PLANNING COMMISSION MEETING

LOCATION: TOWNSHIP ANNEX, 7527 HIGHLAND ROAD, WHITE LAKE, MI 48383
THURSDAY, JANUARY 15, 2026 – 6:30 PM

RE: Edendale Crossing- Preliminary Site Plan Review – 4th Review

Our office has performed a Preliminary Site Plan review for the above-mentioned revised plan dated December 18, 2025. The plans were reviewed for feasibility based on general conformance with the Township Engineering Design Standards.

TYPICAL ROAD SECTION "A-A"

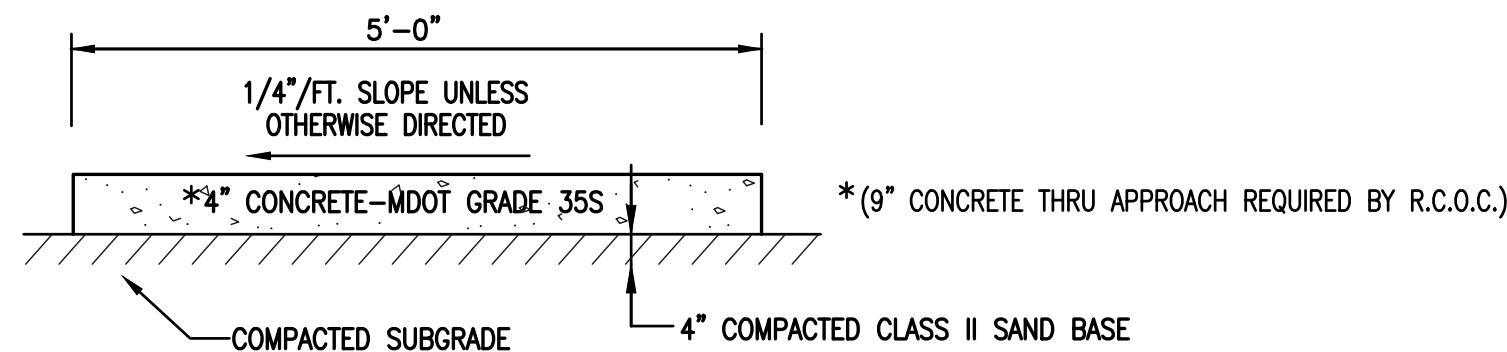
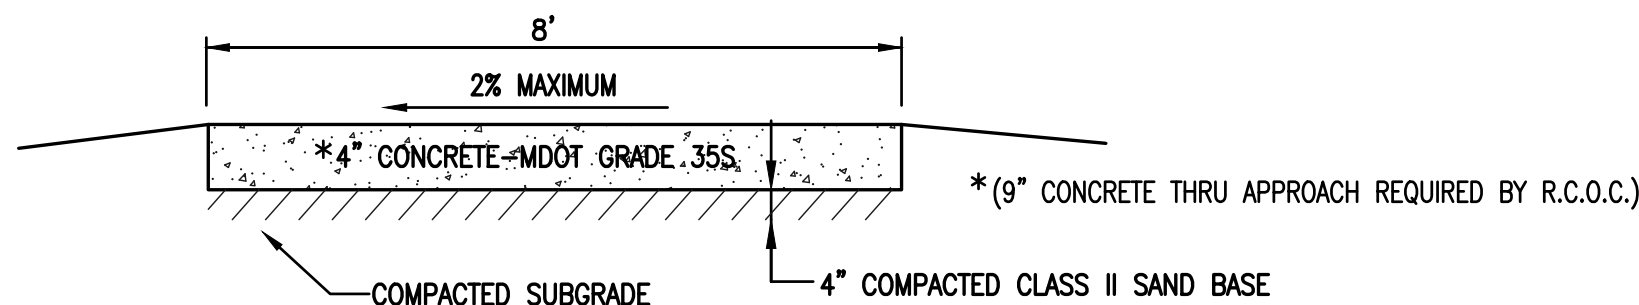
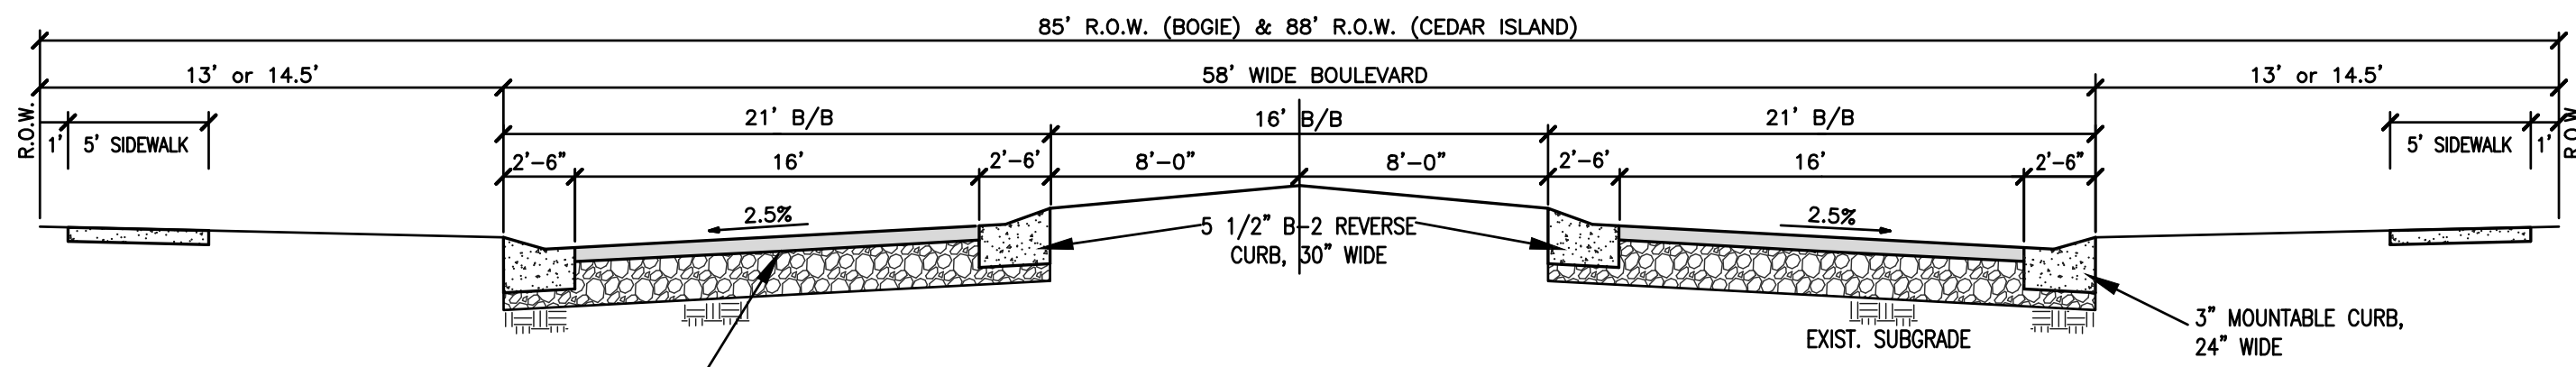
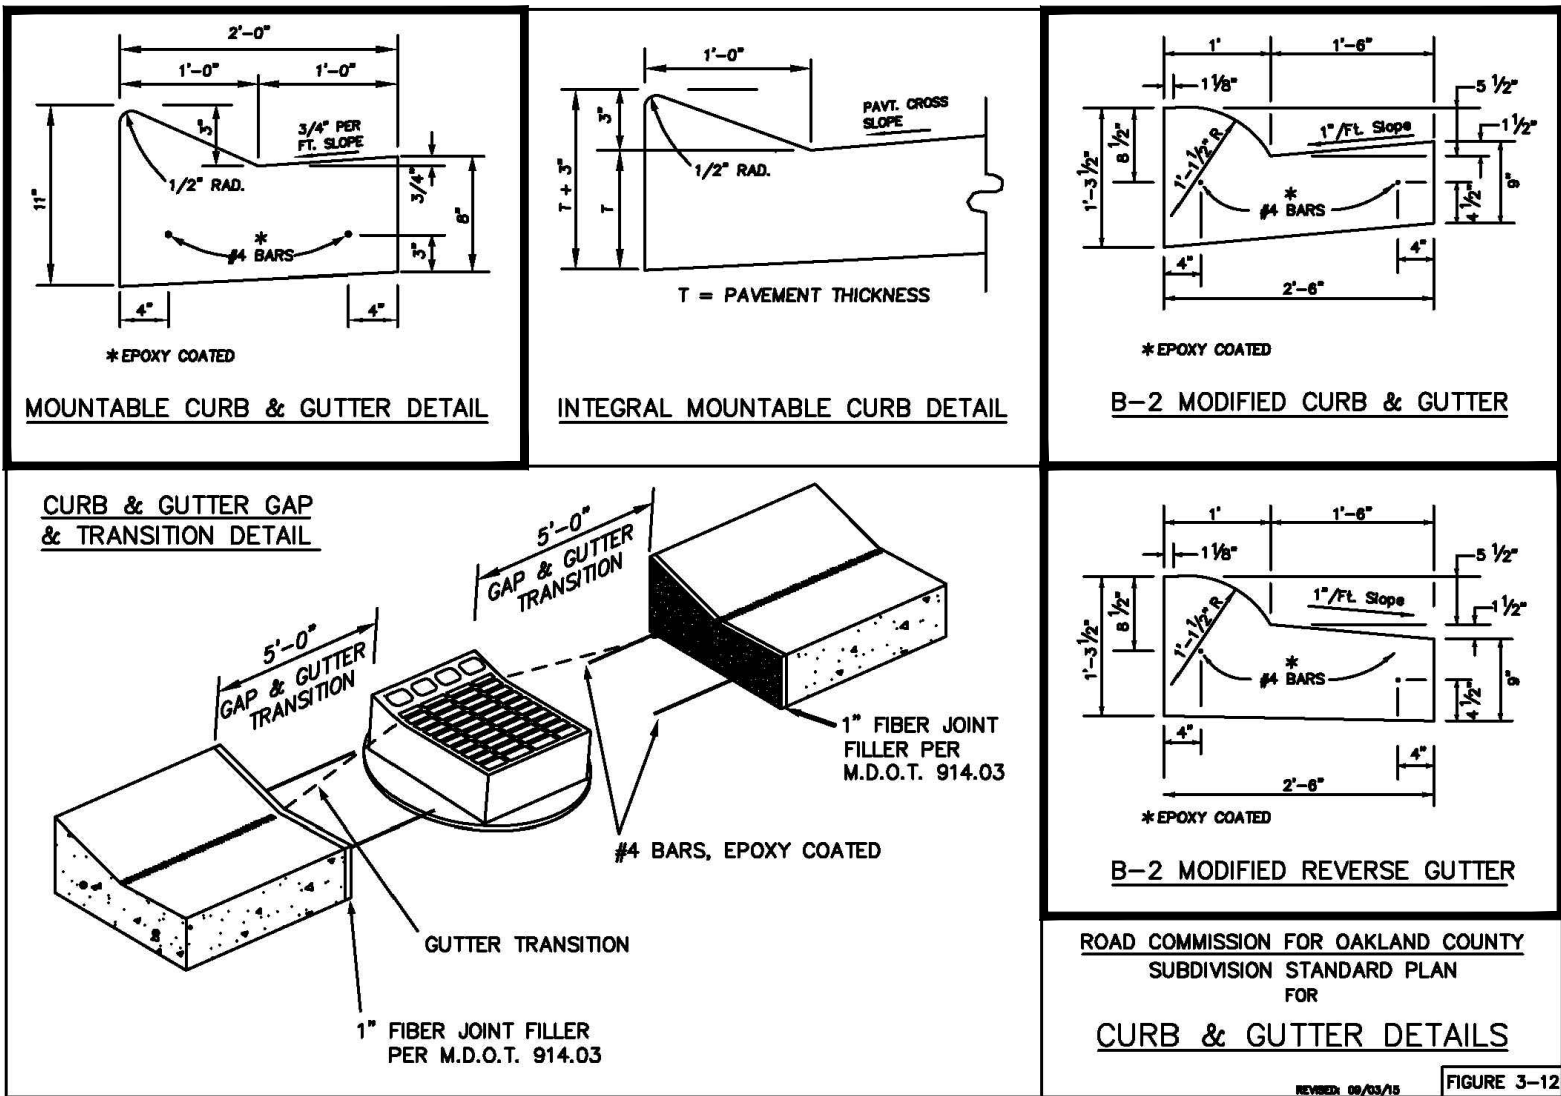
Provide these numbers.

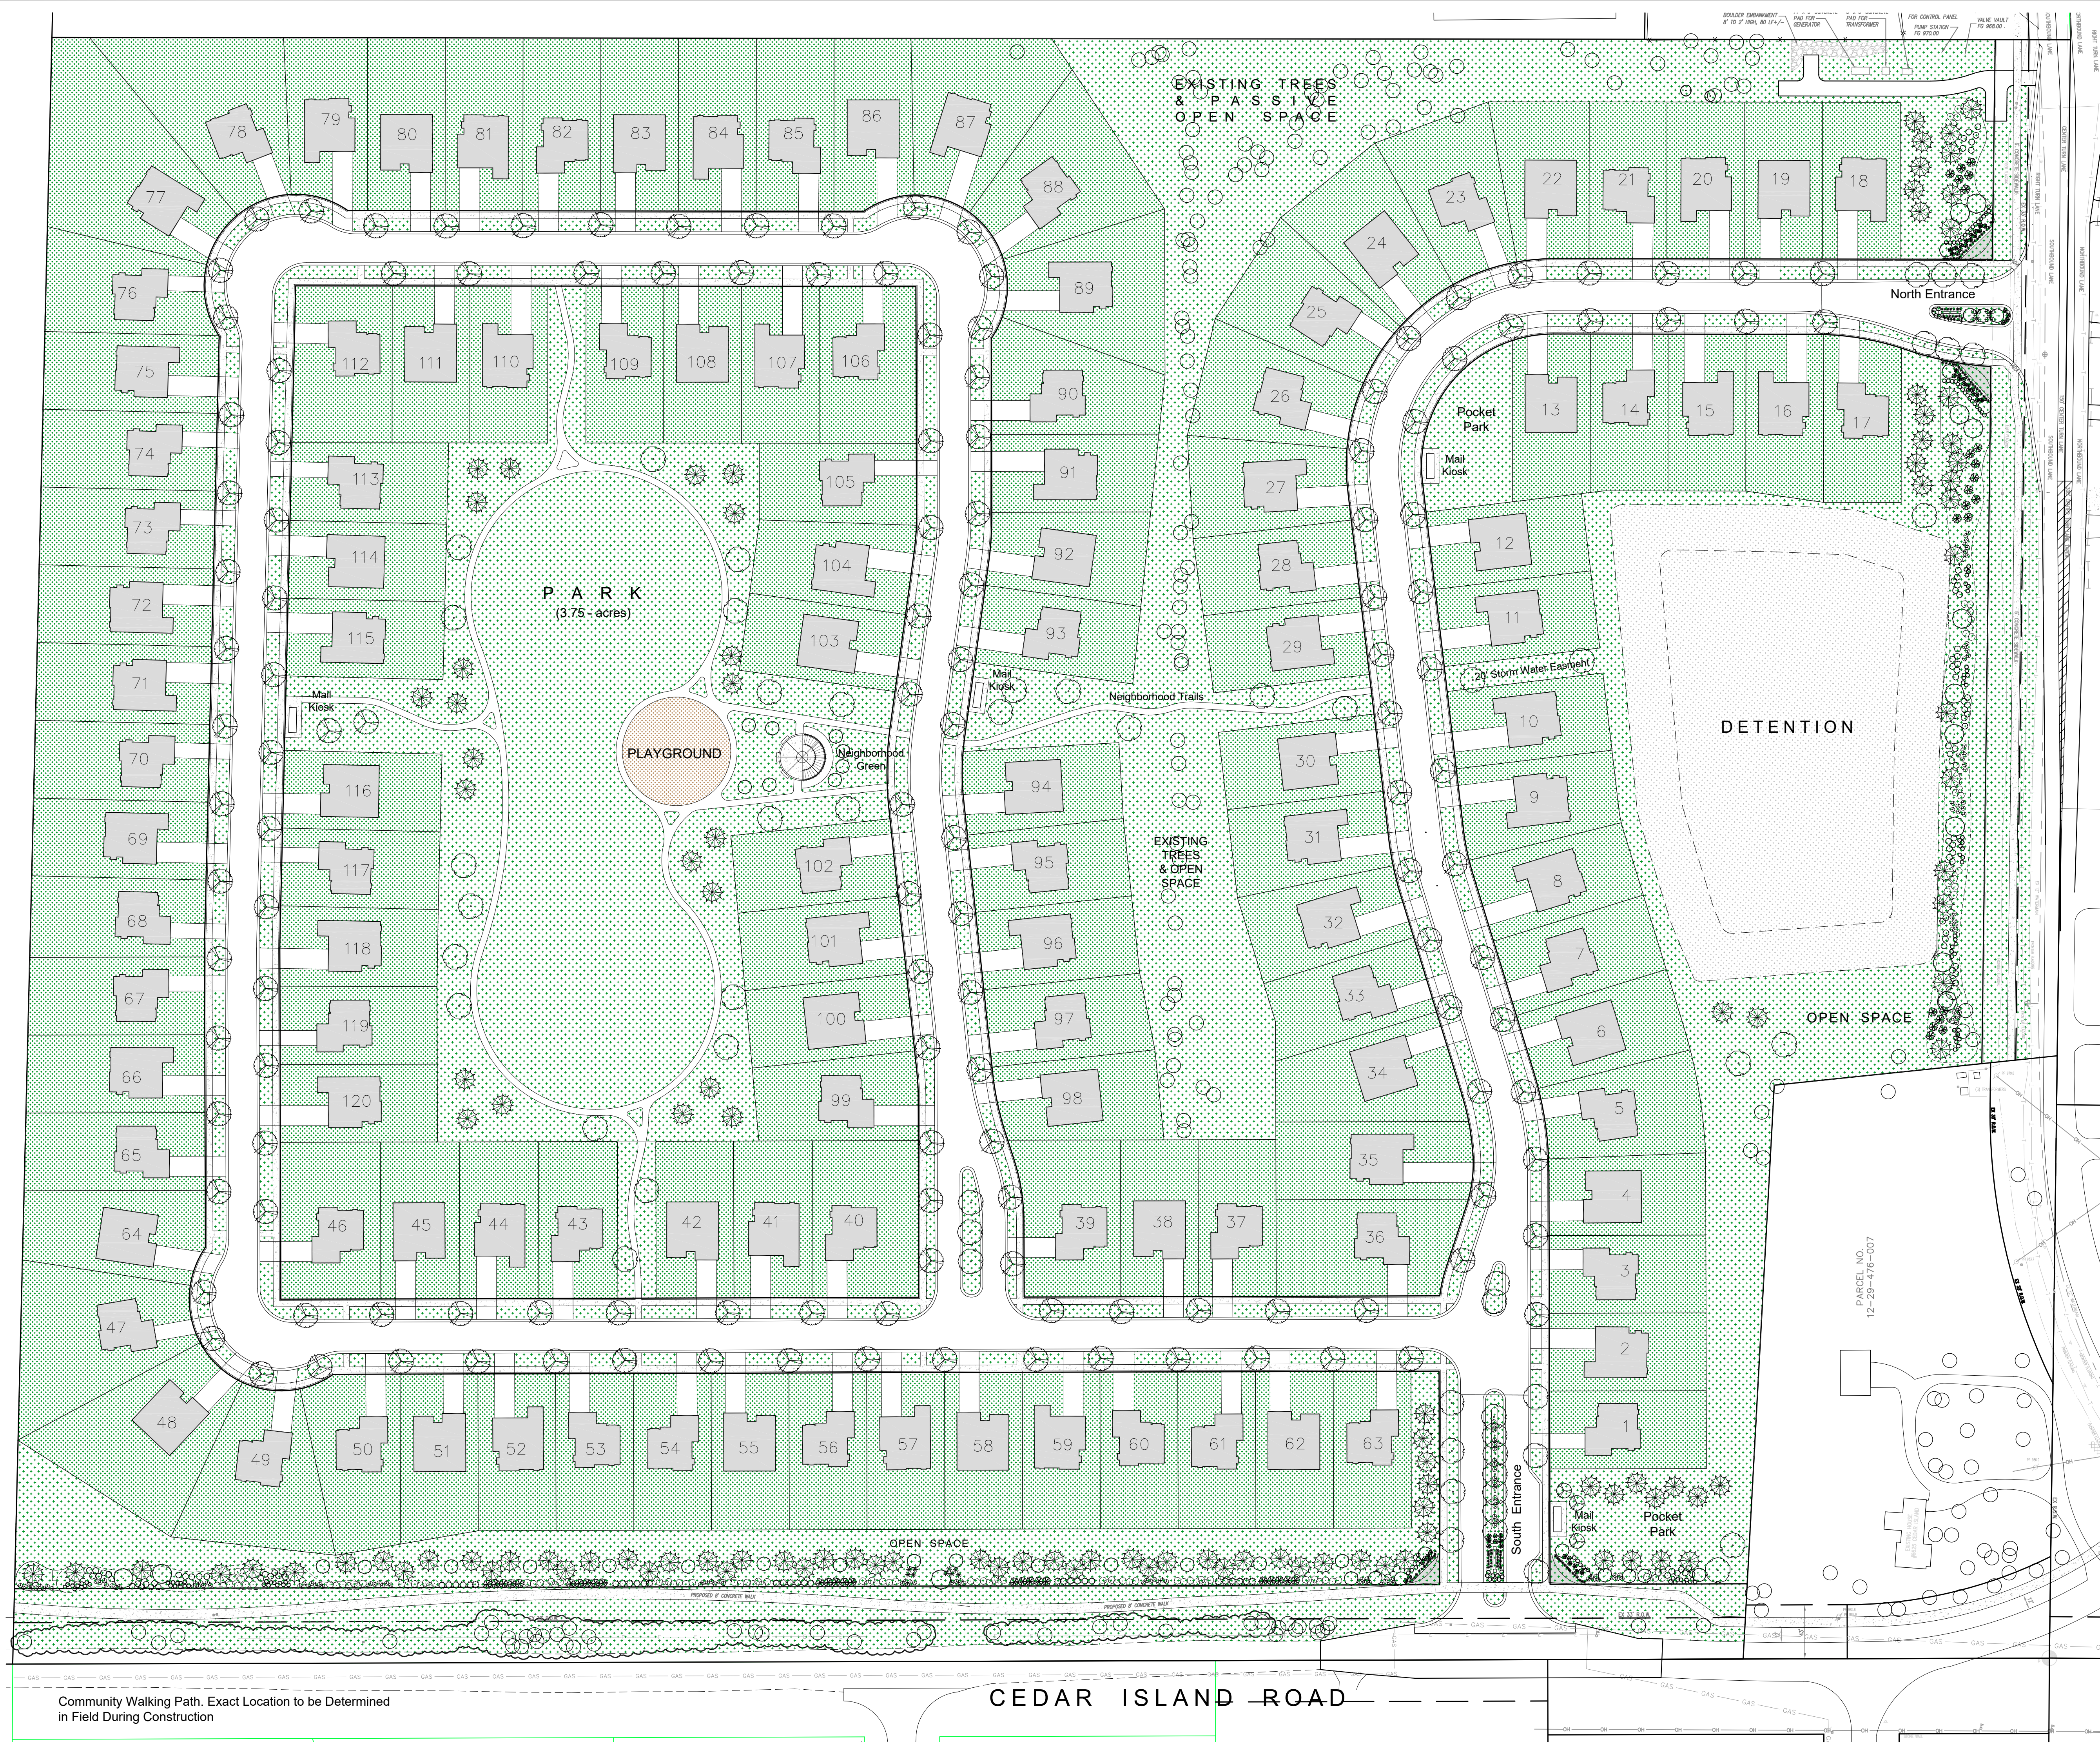
1. *Plan by J. Eppink Partners, Inc. dated September 19, 2025- Sheet PSP-1- Site Data- Table- Parcel size is incorrect. Correct acreage is 45.47. This is also incorrect in the same table in the Proposed Density calculations as well as the Existing AG& R1-A Zoning Parallel Plan(Sheet PSP-2). **Comment addressed. Acreage error has been corrected.***
2. *Sheet 19-Cedar Island & White Lake Middle School Sidewalk Plan- Remove 'Proposed Pedestrian School Crossing' note to the west of Carla Hills Drive as this was where the safety path was previously proposed. **Comment outstanding.***
3. *Sheet 3- The number of lots for each phase has not been updated to correspond with the reduction in total units from 125 to 120. Please update.*

Sheet 3 of the site plan indicates the project will be implemented in two phases. Phase 1 will focus on portions of the site adjacent to Bogie Lake and Cedar Island Roads. Phase 2 fill out the northwestern portion of the site. Sheet 3 outlines the previous unit count for phasing and should be updated.

- 1) *A schedule for the proposed phases is required. Sheet 3 outlines the previous unit count for phasing and should be updated.*
- 2) *The proportions of brick and siding proposed on the façade of the units is complementary, however it is recommended that the brick also be included in a similar proportion on the side and rear elevations.*
